Clonburris T3

Road Safety Audit Response Report

CLB-T3-ZZZ-SW-DTM-RP-DBFL-CE-0005

Location (G1) – Dropped Kerbs and Tactile Paving Problem

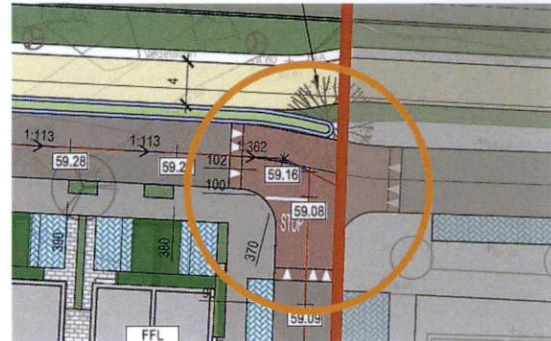
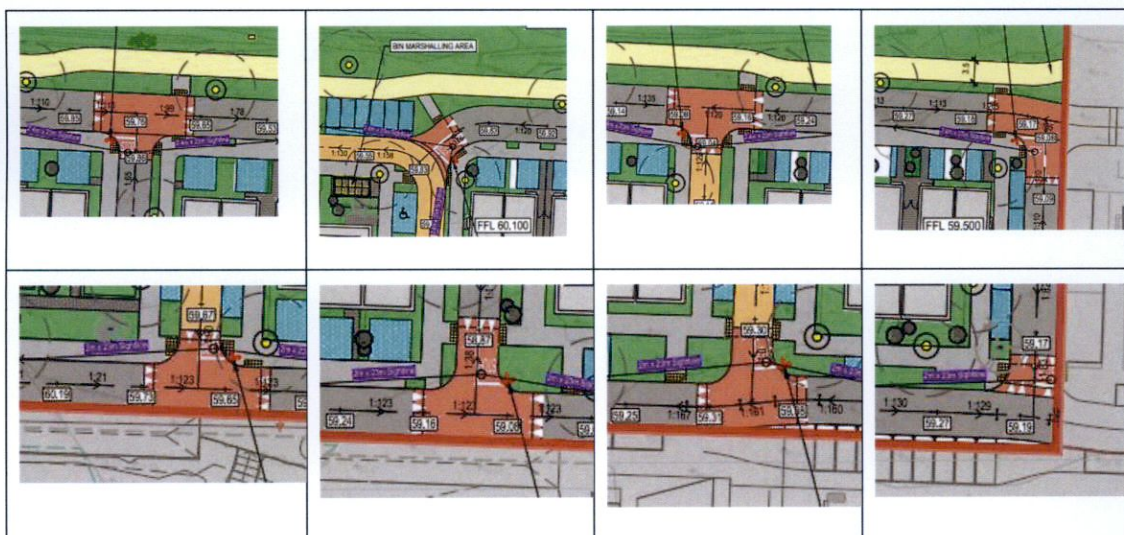
The drawings provided for the purpose of the RSA do not show provision of dropped kerbs and tactile paving at certain locations where pedestrian crossing points are proposed. This could lead to accessibility issues for road users, particularly wheelchair users and can cause confusion for partially sighted pedestrians who may encounter difficulties when crossing the road carriageway.

It is recommended that dropped kerbs and / or tactile paving in accordance with the appropriate design recommendations is provided at all key pedestrian travel desire lines that require a pedestrian to cross a road carriageway.

Pedestrian road crossing points and tactiles at all appropriate locations have been added to ensure safety of regular and disabled pedestrians. Key pedestrian desire lines have been considered at intersections and as close as possible to the middle of residential housing blocks.

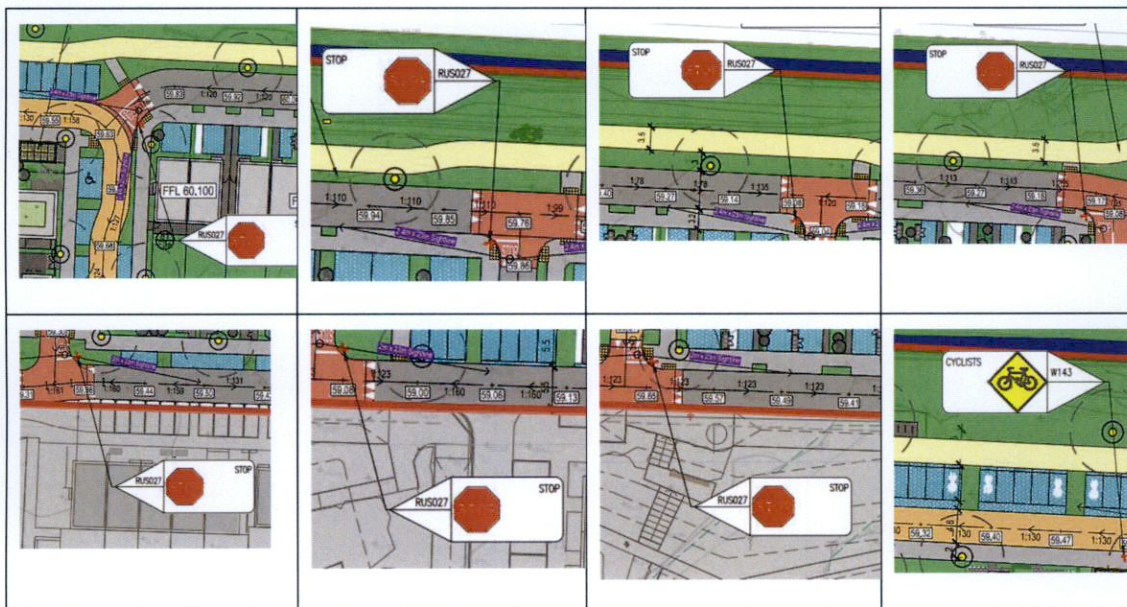
junctions which may lead to side impact collisions with vehicles travelling along the major arm through junctions.

It is recommended that appropriate road marking and signages are provided in accordance with the requirements of the Traffic Signs Manual.

Proposed signage has been added to the roads layout drawing CLB-T3-95-SW-DTM-DR-DBFL-CE-1201 in accordance with the Traffic Signs Manual.

Location (G4) – Street Lighting

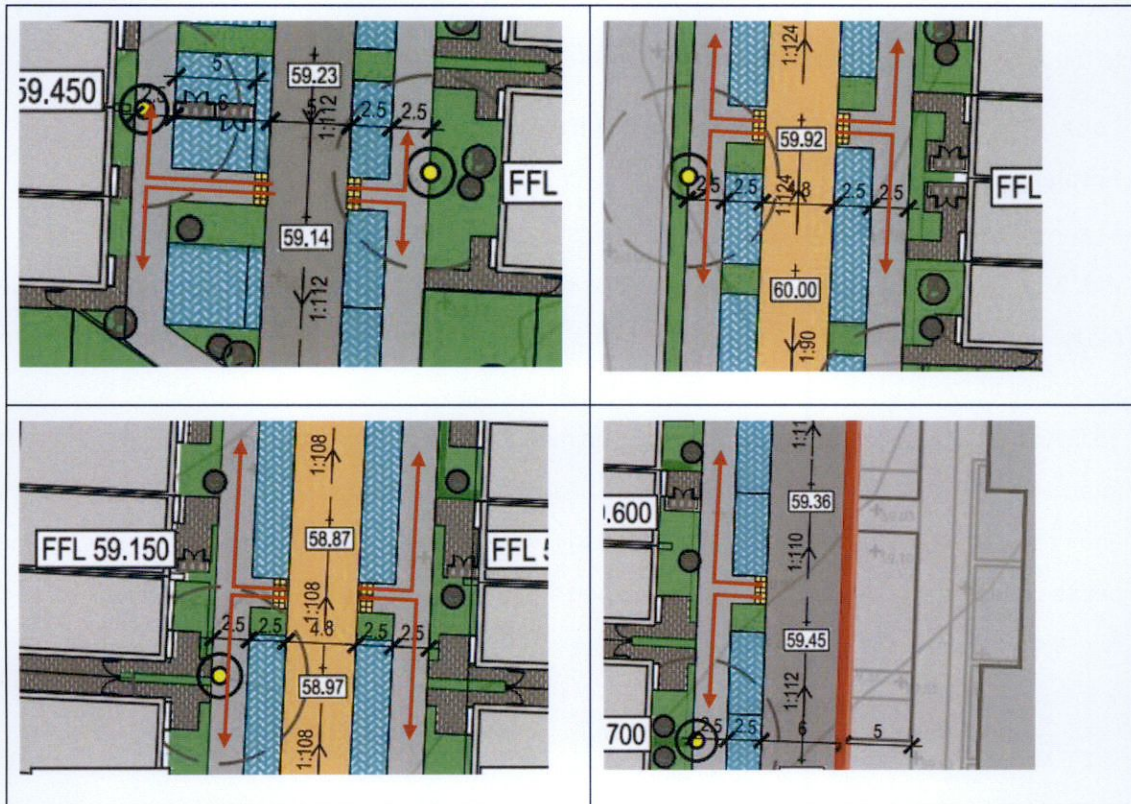
No details regarding the proposed schemes street lighting have been provided to the audit team. As a result, the audit team cannot comment upon the appropriateness of the proposed schemes street lighting strategy.

Ensure appropriate street lighting is provided across all pedestrians, cycle, and vehicle routes.

the middle of the streets to allow a link from the houses to the road for bin collection. Refer to drawing CLB-T3-95-SW-DTM-DR-DBFL-CE-1201 for further details.

Location (G6) – Surface Drainage

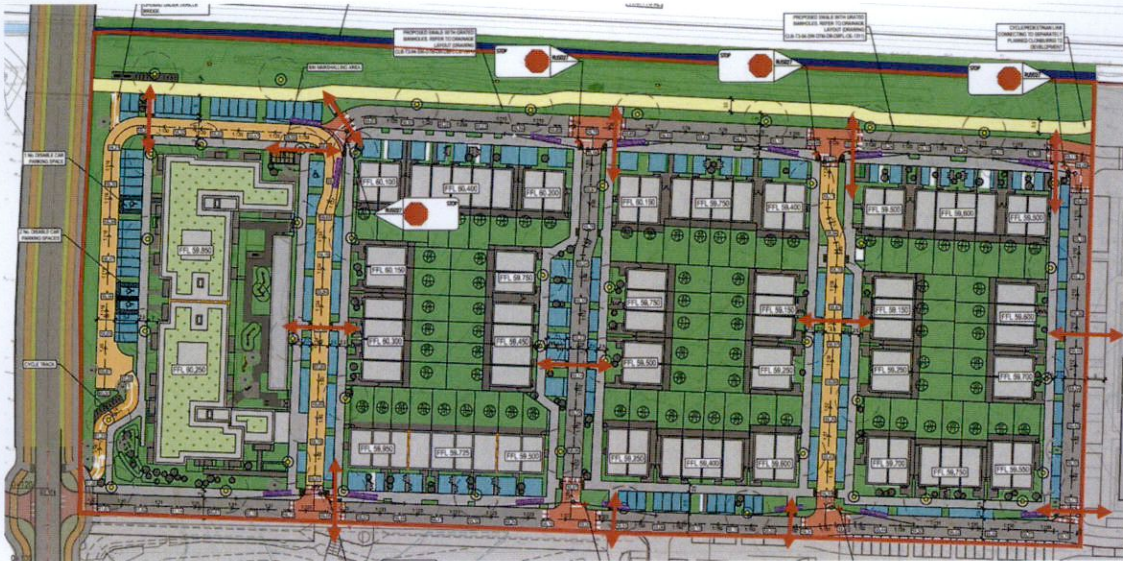
From the scheme information provided for this audit, it has not been possible to ascertain the specific details of the surface drainage strategy. Surface water can prove a trip hazard in both warm and cold weather conditions in addition to adversely impacting the skid resistance of bicycles and motorized vehicles.

During the detail design stage, the design team should provide adequate measures are taken to ensure that all surface areas benefit from having sufficient drainage and that localised ponding does not arise during wet weather conditions. All access routes leading to/from the subject site should have adequate surface water drainage.

Appropriate pedestrian crossing points have been added at all desire lines indicated in the Road Safety Audit. Refer to drawing CLB-T3-95-SW-DTM-DR-DBFL-CE-1201.

Location (G8) – Long Straight Sections of Carriageway

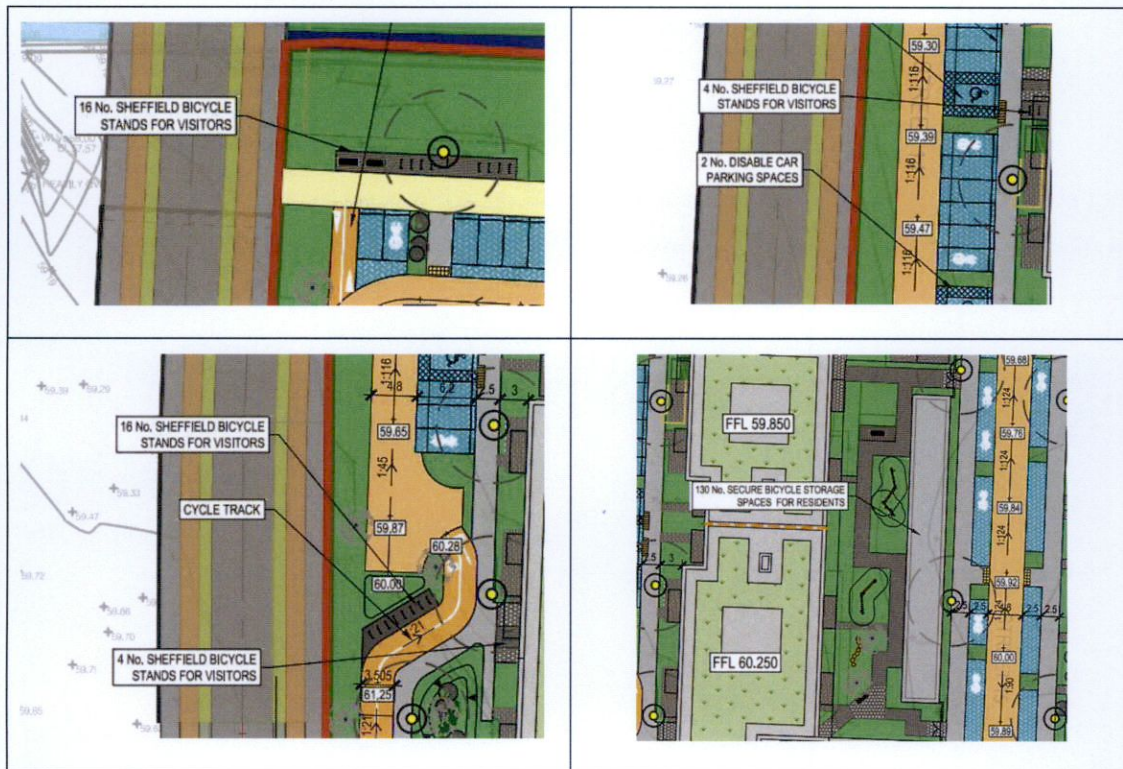
The internal local roads exhibit long straight sections with the carriageway lacking necessary traffic calming measures. This could lead to high excessive vehicle speeds. Higher speeds would lead to higher severity injury collisions should a driver lose control or come into contact with another road user.

The designers are requested to confirm the adopted design speed for each of the development streets. It is recommended that suitable traffic calming measures are provided to manage vehicular speeds along the local road/streets and ensure vehicle drivers do not exceed the adopted design speed. The measures should be in compliance with the principles set out in DMURS in regards to managing vehicle speeds.

The design speed of the development is 30km/h. Several bends in alignment have been introduced in Local Streets and different carriageway treatment utilised in Home Zones to manage vehicle speeds. Additional raised intersections and pedestrian crossings have also been introduced to

Location (G10) – EV Parking

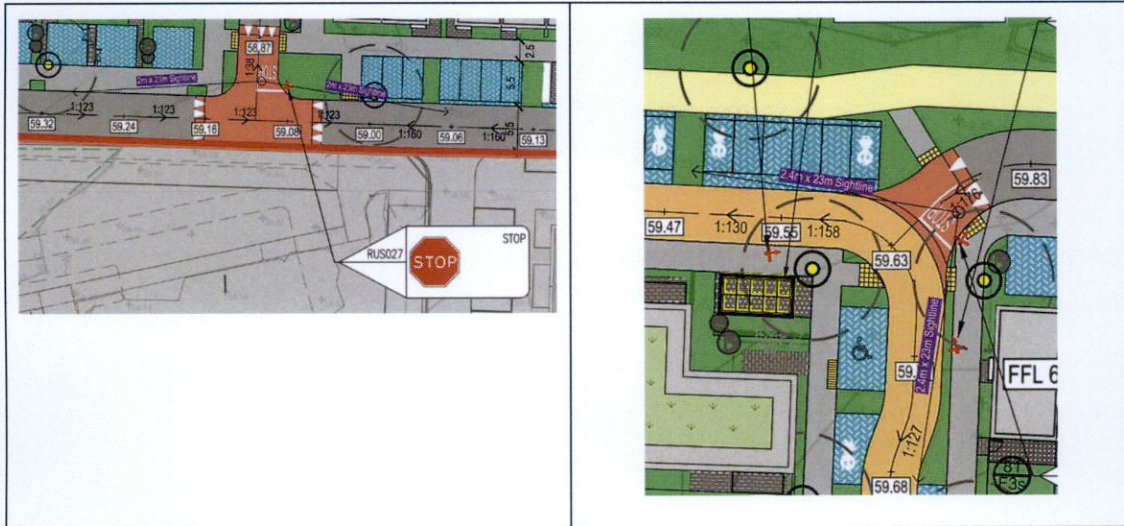
It is noted upon review of TTA report that a minimum of 34 no. electric vehicle (EV) parking spaces will be provided. However, the scheme does not provide details of the location and size of EV parking bays or the location of EV charging points. The auditors are concerned that the proposed EV parking bays may be of a substandard size that could impact accessibility and result in cables encroaching to the public footpath which would represent trip hazard. Furthermore, the auditors are concerned that EV charge point may be located in either 1) the public footpath which could subsequently represent obstruction and /or 2) a grass landscaped area which, particularly in wet conditions, could be slip hazard for drivers seeking to access the charge point.

The designers are requested to confirm the location and size of all EV parking spaces meet best practice design guidance. EV charging points should be located in an area of hard standing, outside of the footpath area, and in close proximity to EV bays.

Visibility splays have been indicated on the roads layout CLB-T3-95-SW-DTM-DR-DBFL-CE-1201 to ensure there are no obstructions to any vehicle sight lines at junctions

Location (S5) – Tactile Paving

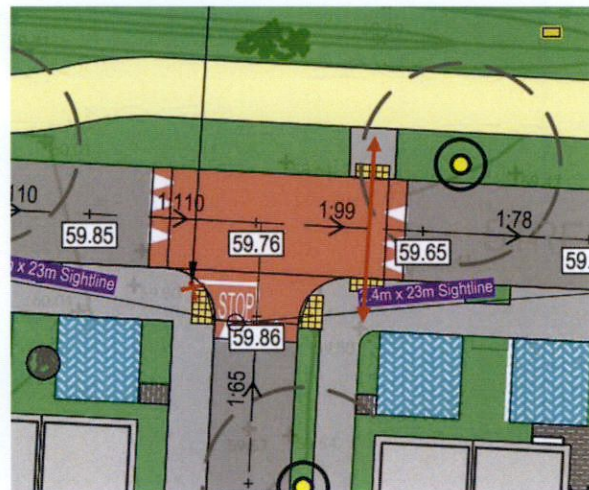
The tactile paving on the eastern edge of the minor arm is misleading and would currently direct visually impaired pedestrians towards the carriageway resulting in collisions .

Ensure tactile paving is appropriately placed . A separate tactile paving should be provided for north-south movements at the eastern arm of this junction.

Separate tactiles have been provided for the north-south and east-west pedestrian routes to avoid any confusion of visually impaired users of the footpaths.

Location (S7) – Lack of Vehicle Turning Head

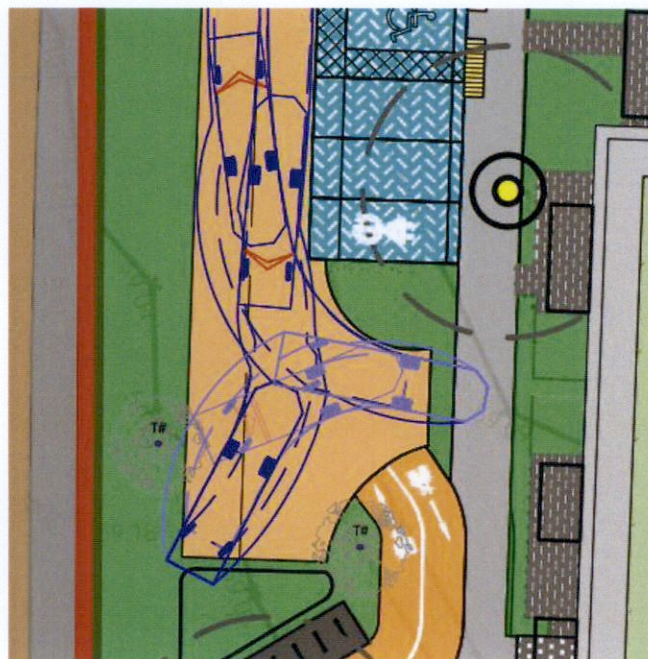
It is unclear how cars and large refuge vehicles will be able to access and undertaking u turn manoeuvre at the southern termination of the north-south street located immediately to the west of apartment block at the western edge of the site. The auditors request clarification regarding how large vehicles can be accommodated as the road terminates with a cul-de-sac.

To ensure a safe and convenient turning movement at this location, it is recommended to provide a turning head on this carriageway.

A turning head has been added to the end of Street 14 to allow sufficient turning space for a fire tender vehicle. Refer to drawing CLB-T3-95-SW-DTM-DR-DBFL-CE-1202 for further vehicle tracking details for the site.
